INDESIT company

MBM1812FFRHA

F053485

n1030097: No-frost combi 28 watt drip tray heating element (width 60) Ariston - Indesit

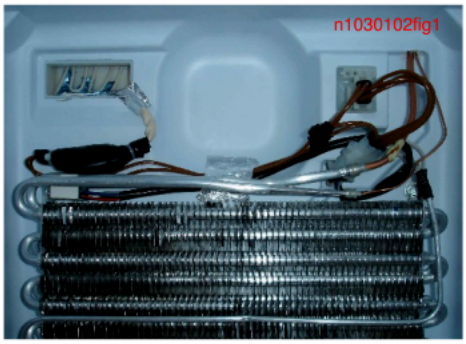
In the event of breakage of the heating element utilised on the appliance for defrosting of the drip tray, use the 28 watt heating element (C00140585) and cable supplied as replacement parts.
For the use of these parts refer to the Technical Bulletin "TB001007" (ex STN - CL 0602.2) sheet entitled: "Broken drip tray heating element Platform 2005 NF W60"
